Re: 339 West Gorham Street: Oliv Madison

Attached is a minor amendment packet for the Oliv Madison Project. These changes address some program elements (expanded amenity), design refinements, and adding solar to the project. The packet illustrates the changes between the Original SIP document and the proposed amendments. The site plan review/building permit set elevations are also included for reference to show what was approved with the building permit.

UDC MINOR REVISIONS

OLIV MADISON 339 W GORHAM STREET

A45

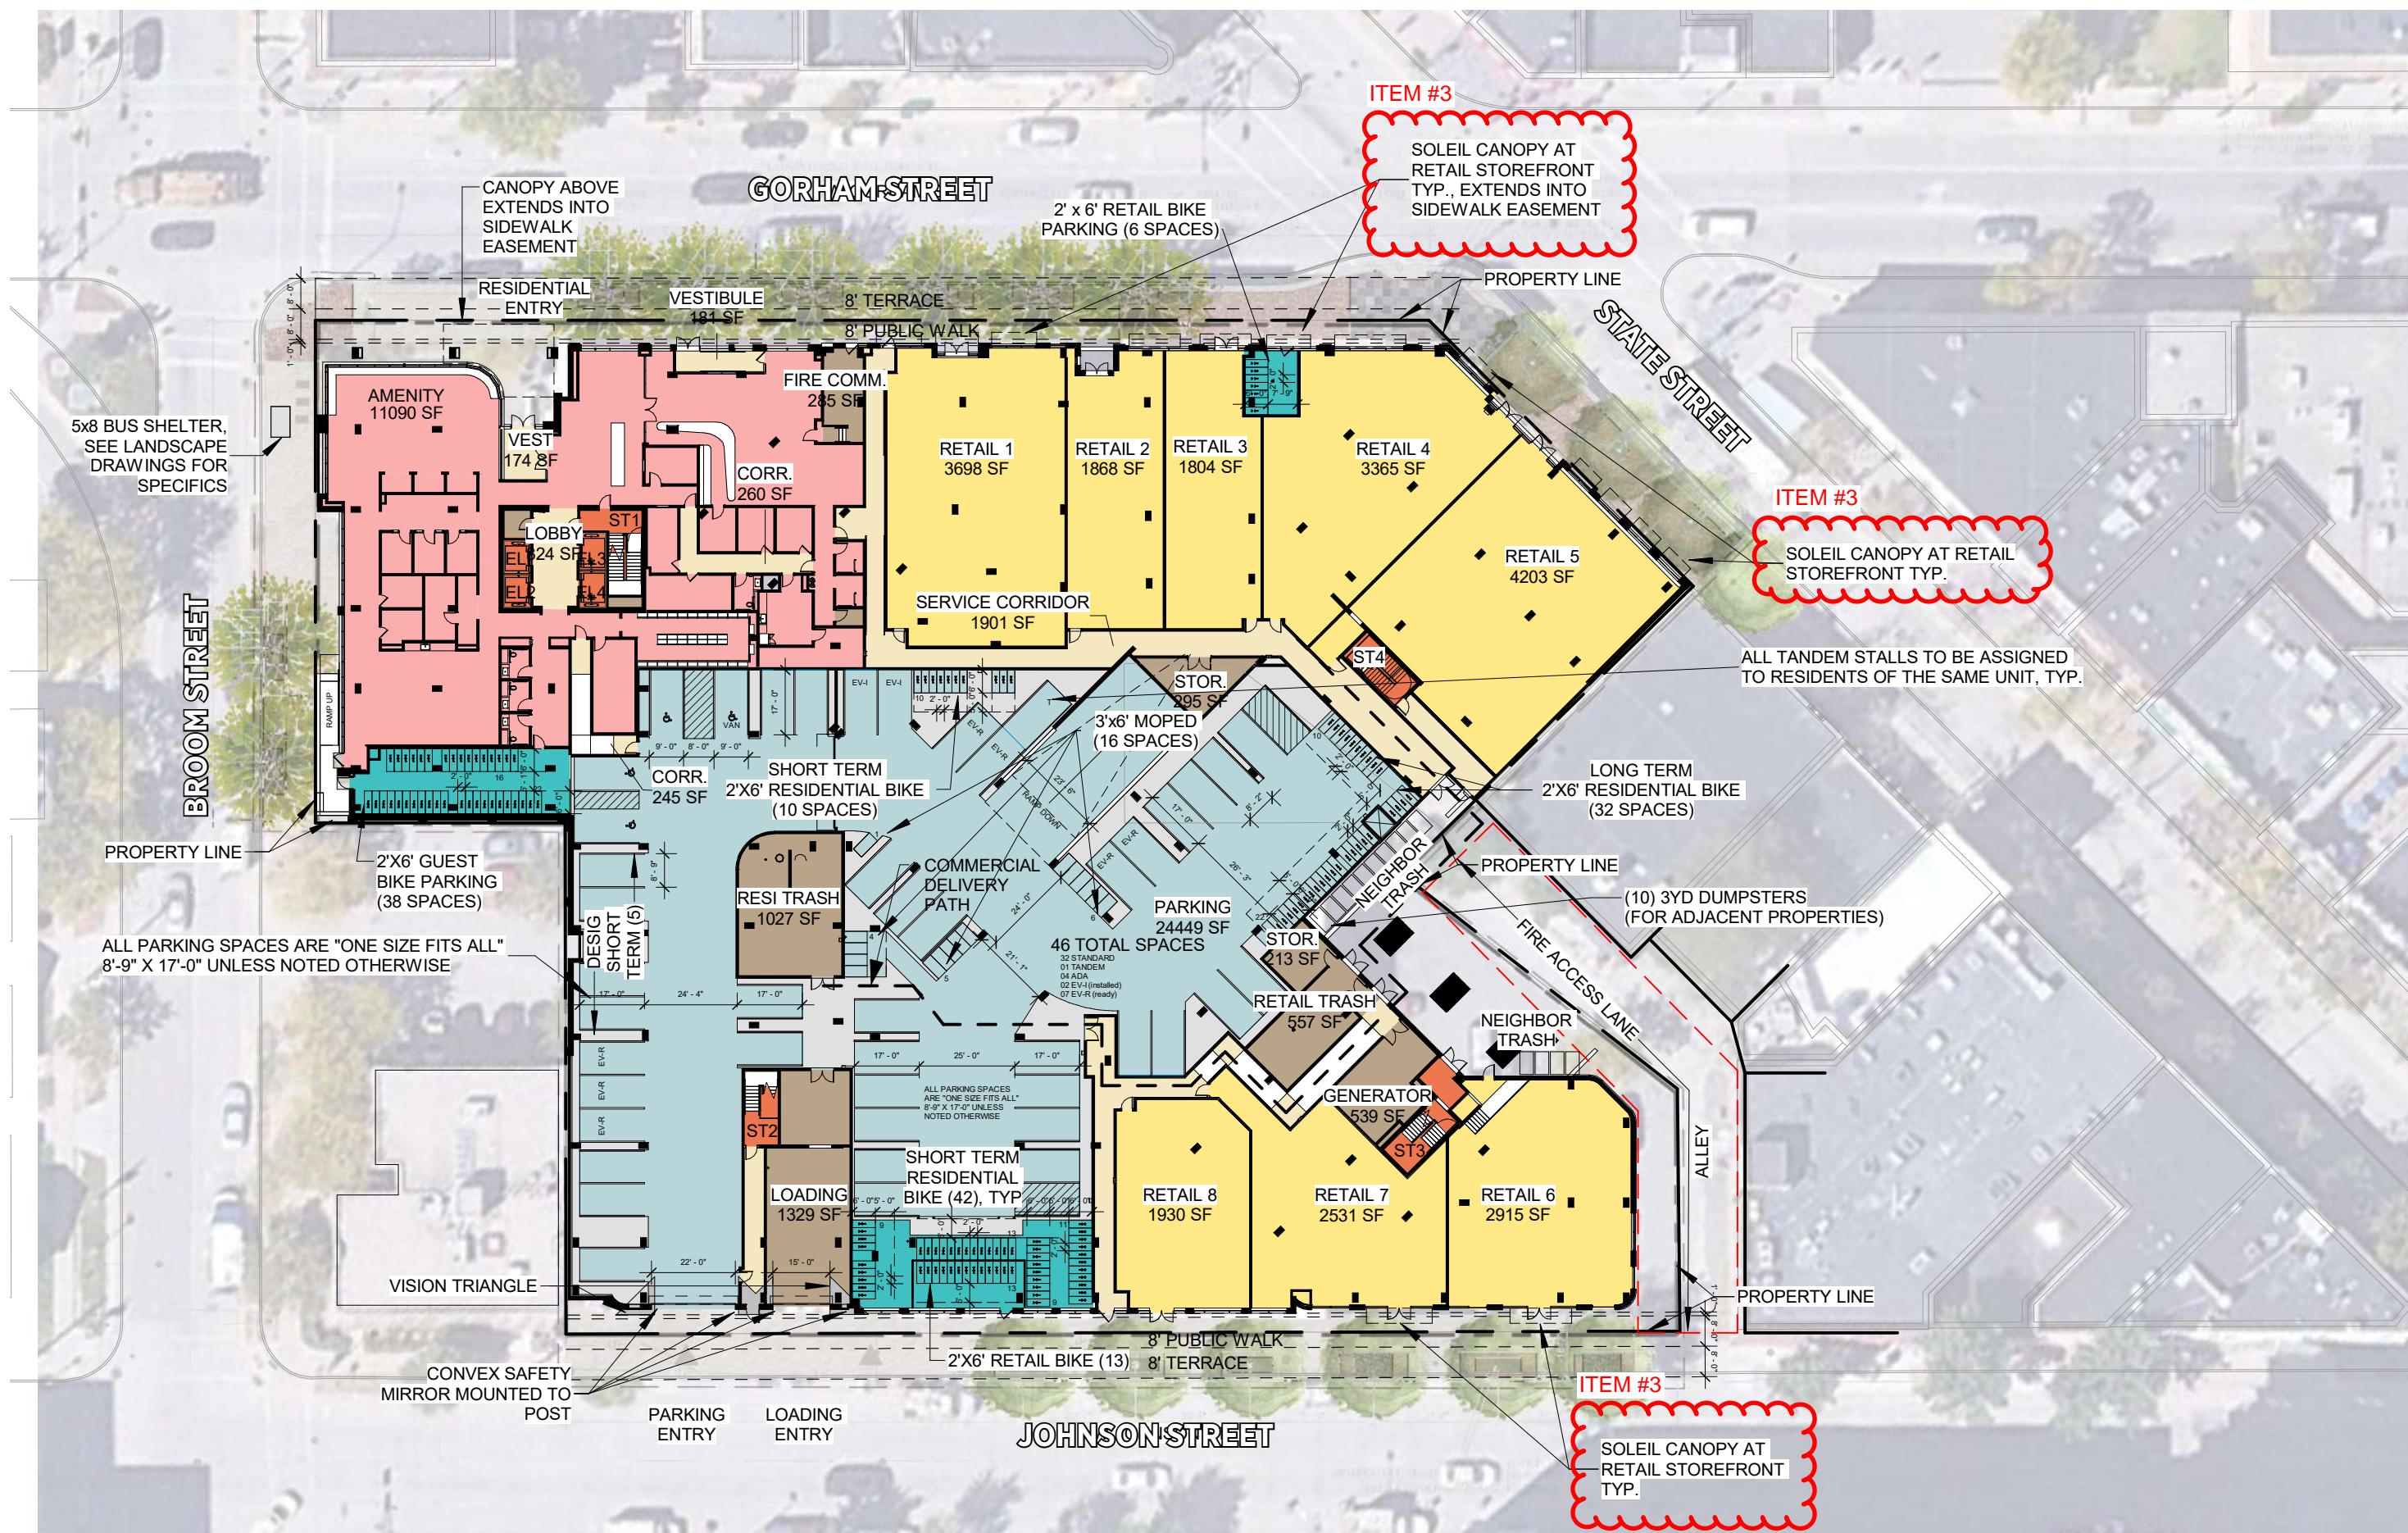
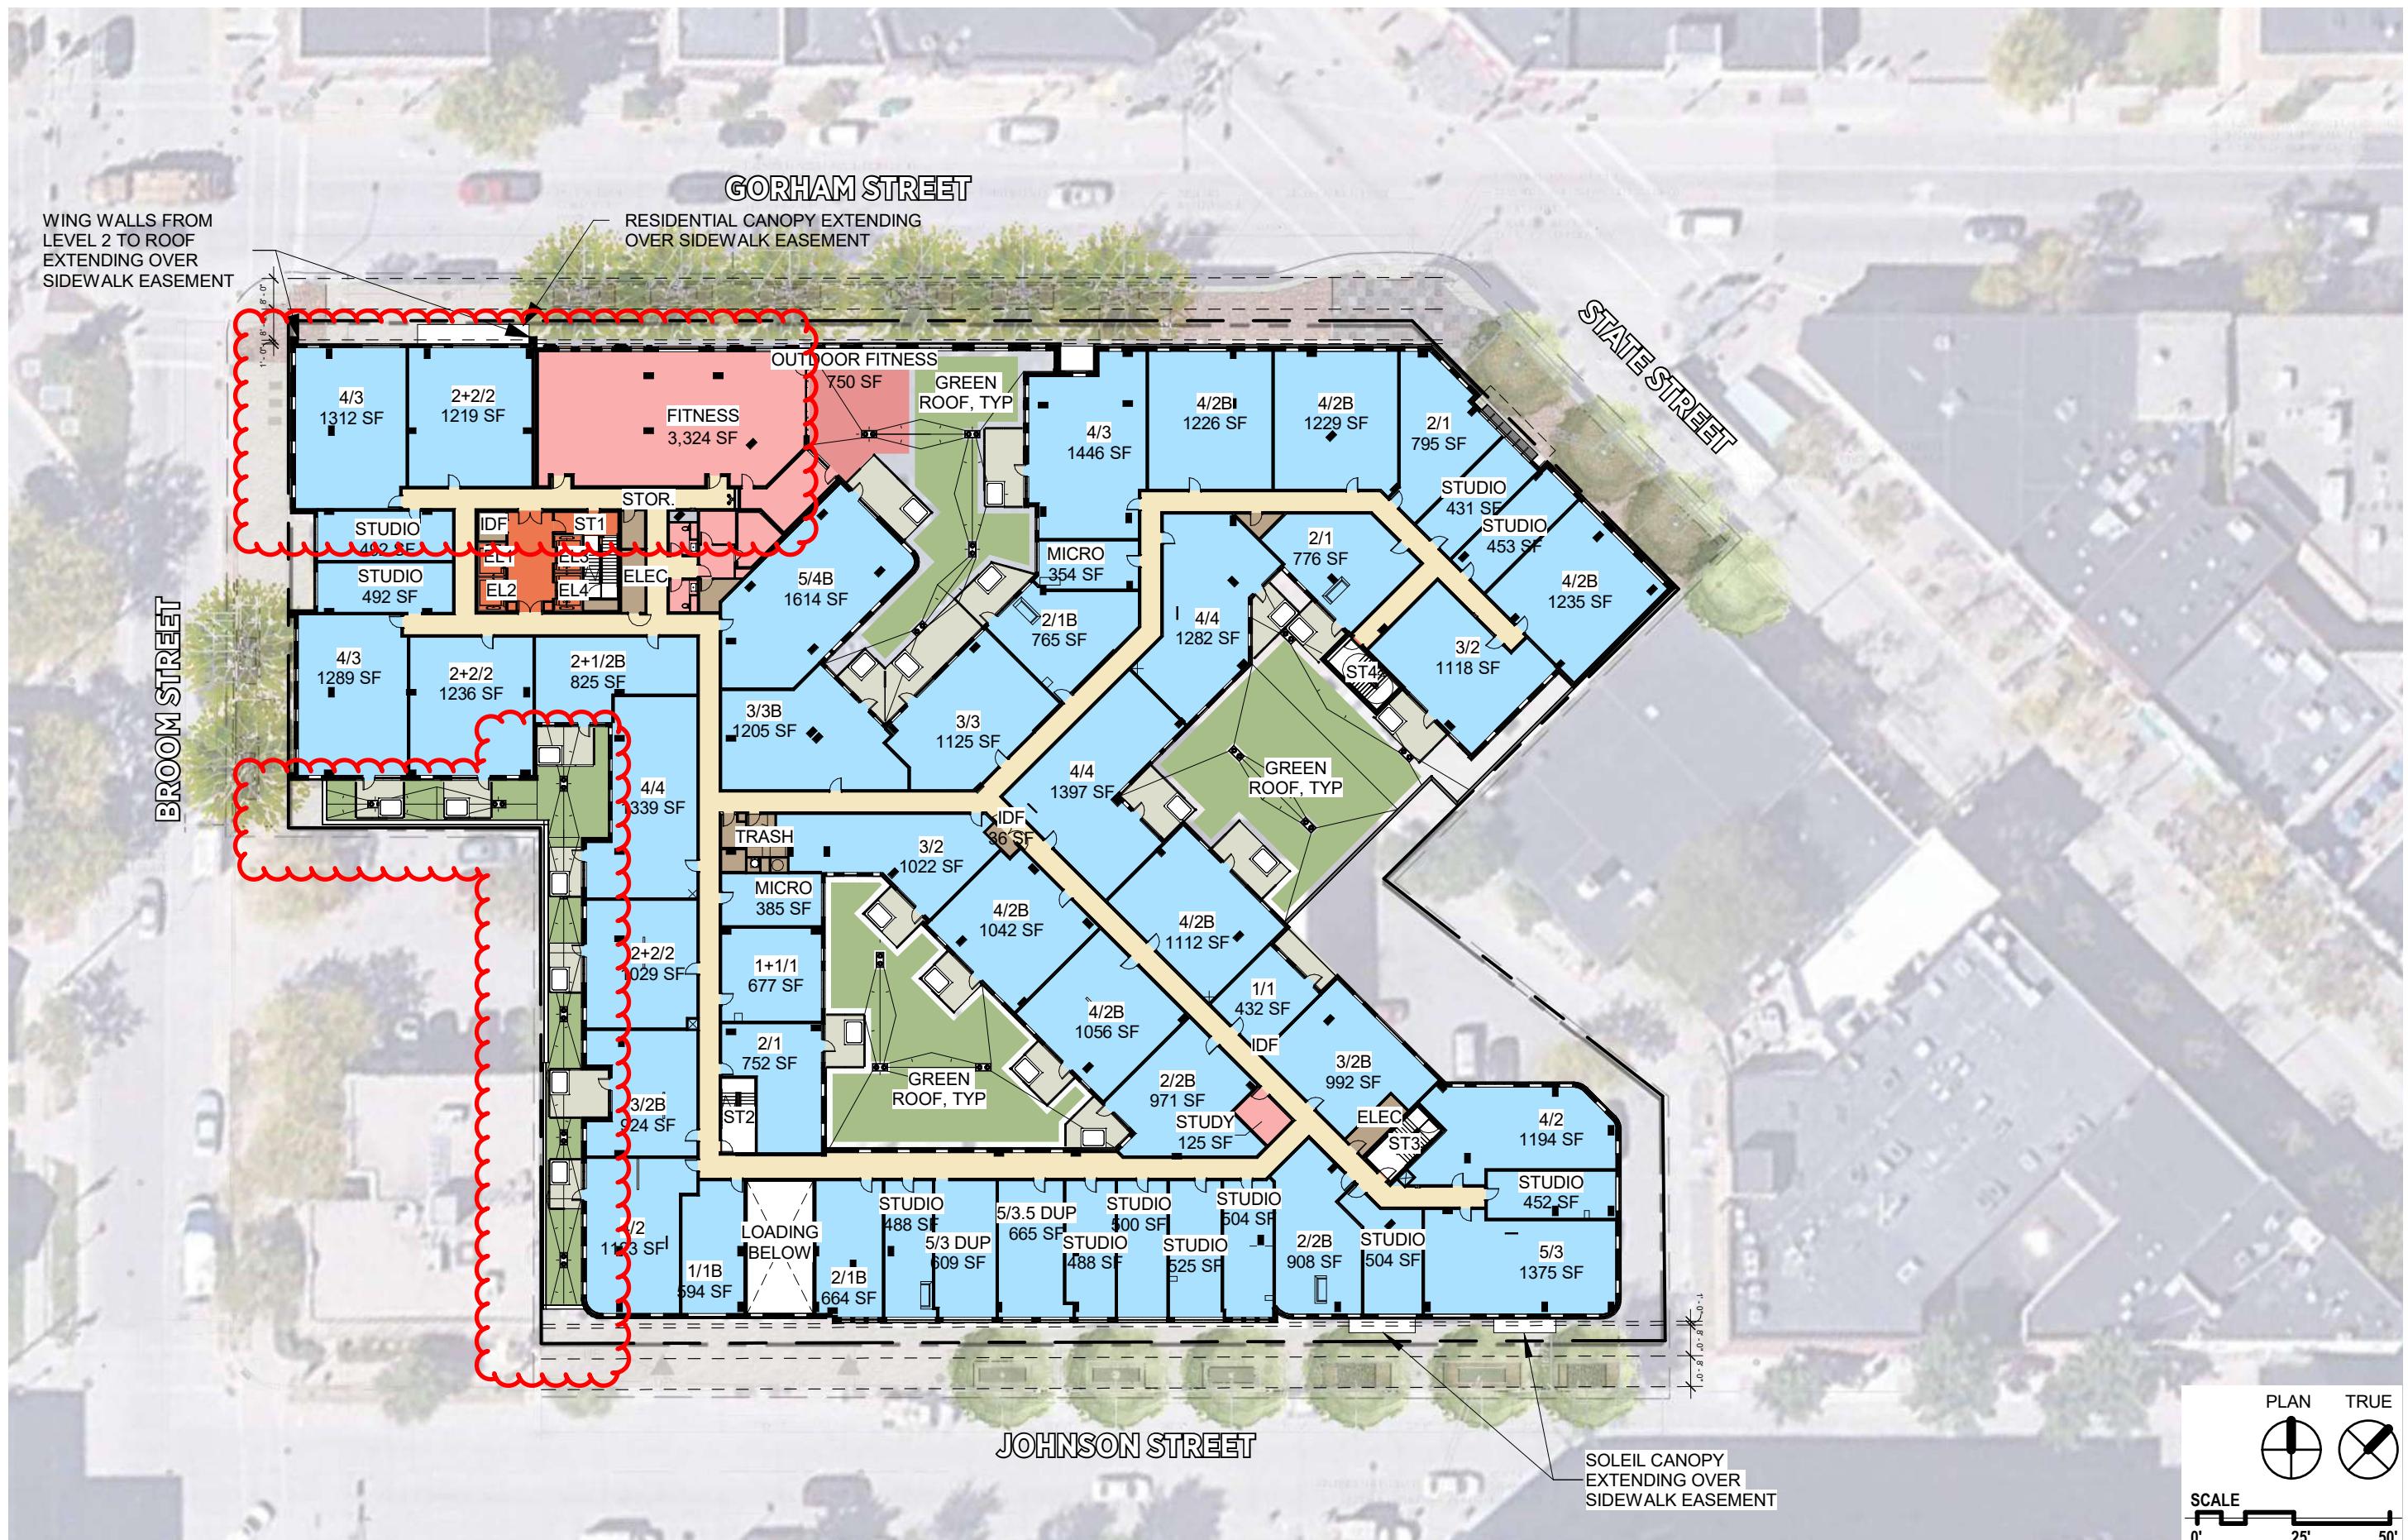
- Item 5. Increased Fitness Room size (A45): Revise 2nd floor to remove one unit, revise adjacent unit, and expand fitness amenity space (net reduction 1 unit and 3 beds).
